TECHNICAL BULLETIN TECH-03-2021

VW 2.0L - 830324-5004S TURBOCHARGER REPLACEMENT

12TH MARCH 2021

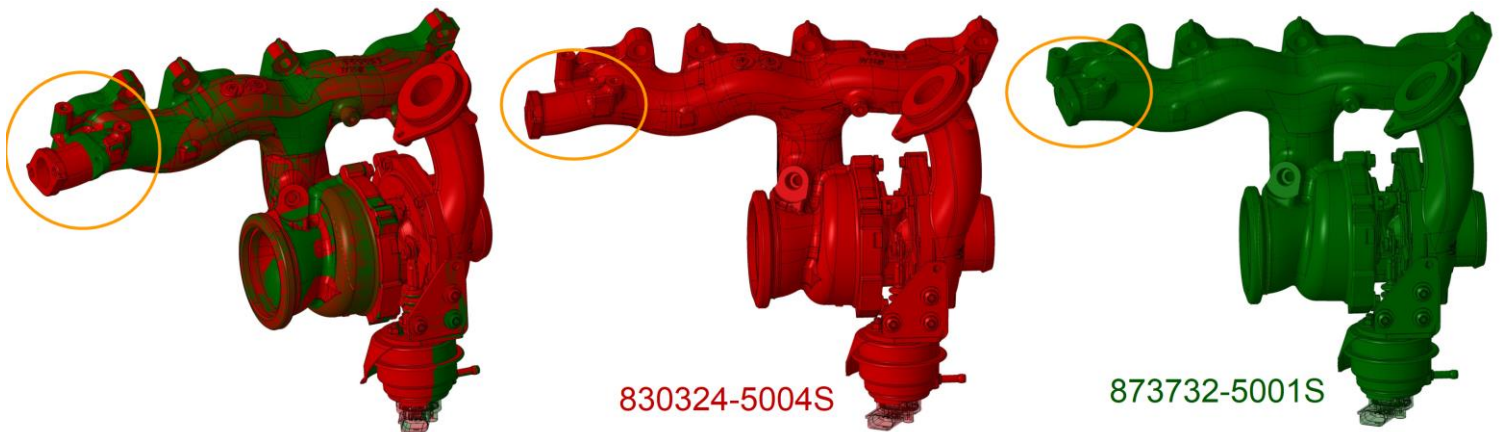
As a replacement is available turbocharger 04L 253 014 H / 873732-5001S, which is not a direct service replacement for 830324-5004S.

- There is a different position of the flange for EGR pipe on turbine housing – see below

To replace turbocharger 830324-5004S to be ordered following:

- From Garrett - Turbocharger 873732-5001S
- From franchised VW dealer
 - EGR pipe
 - Gaskets
 - Heatshield
 - Necessary fasteners

Parts to be ordered from franchised VW dealer

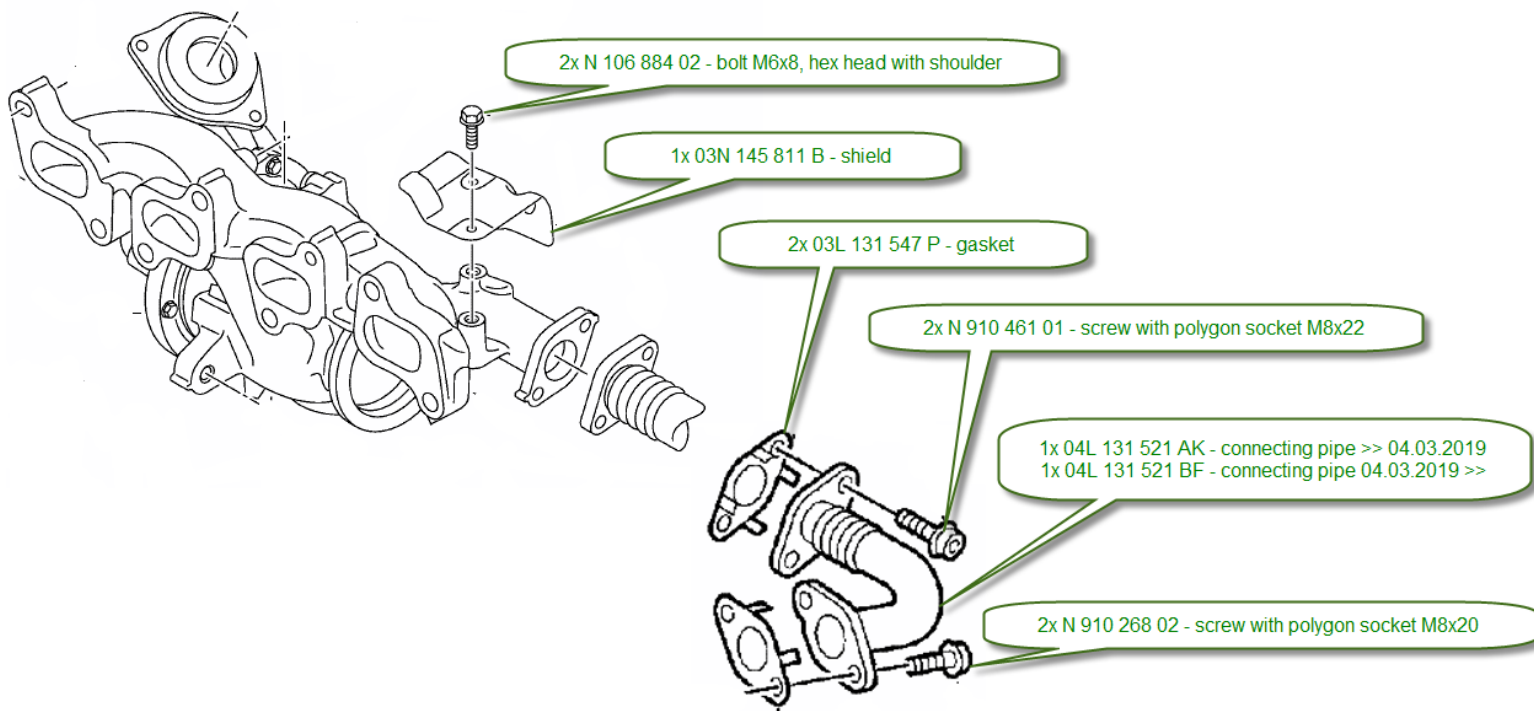
- EGR pipe
- Gaskets
- Heatshield
- Necessary fasteners
